Certified Action of the City of Raleigh Planning Commission

Case File / Name: SP-68-11 / Watts Chapel Baptist Church Parking

SUBJECT: SP-68-11 / Watts Chapel Baptist Church Parking

Staff Report

Proposed Site Plan

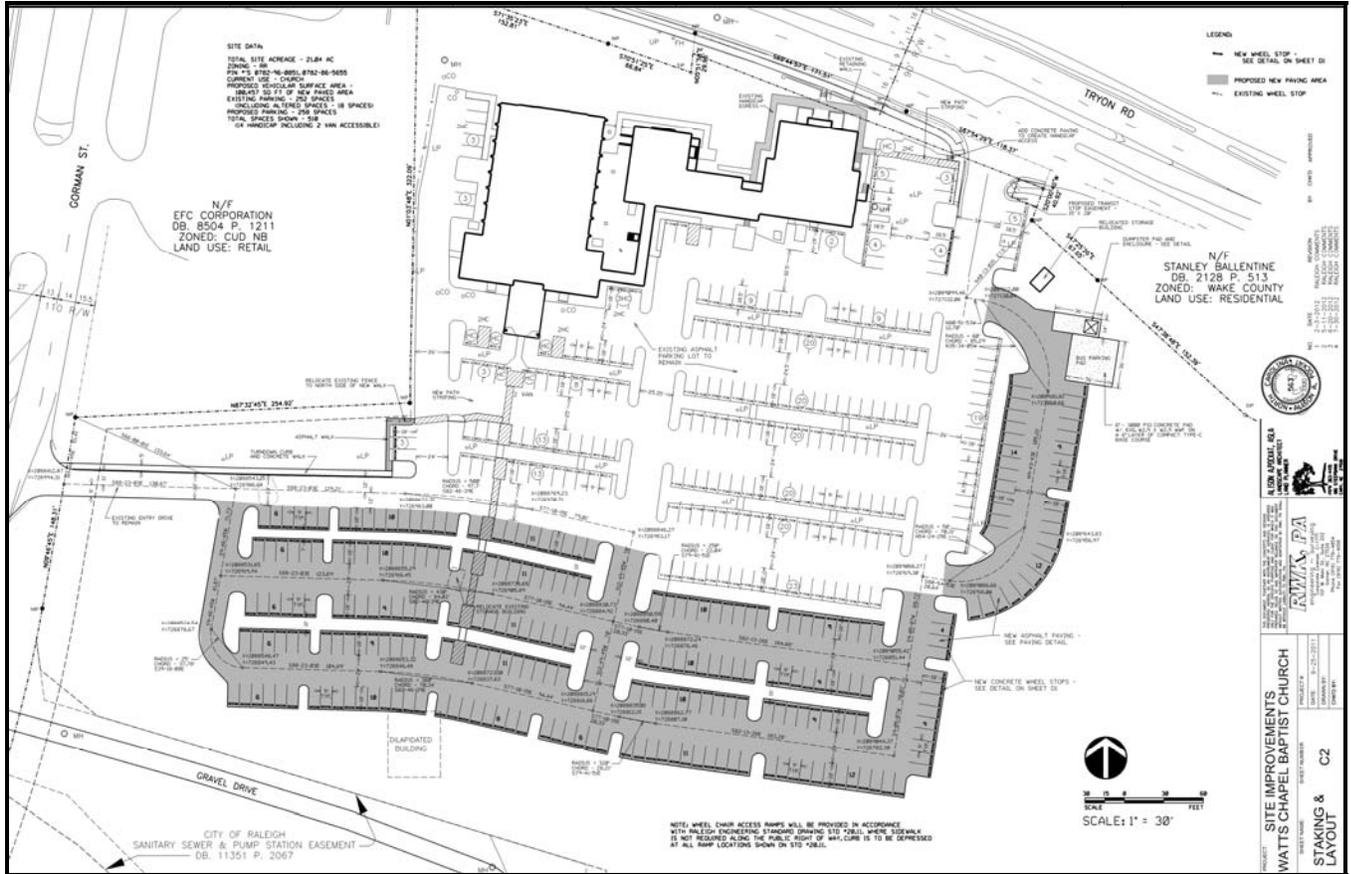
<u>Comment</u>	<u>Response</u>
1) Given the church's Swift Creek watershed location, and that the parking lot expansion is in preparation for a future, not yet planned, addition, the commission recommends the applicants explore ways of reducing the overall percentage of impervious surfaces in the parking lot area.	Every effort to reduce the impervious surface area and still meet the client's needs has been explored.

2) Given the number of parking spaces proposed, the Commission recommends that a linear series of spaces be converted to striped, safe pedestrian ways leading across the width of the lot to the church entrance.	Striping and walk pads have been provided to allow pedestrian access to the rear of the parking lot

3) Please confirm that the proposed dumpster enclosure material matches that of the principal building.	Enclosure materials is in accordance with the City code requirements and will match aesthetically with the current and proposed buildings

4) The commission also recommends the applicant pursue reuse of the existing shed, either intact or deconstructed so that its materials might be incorporated into new building.	Every effort has been made to find a re-use for this structure.
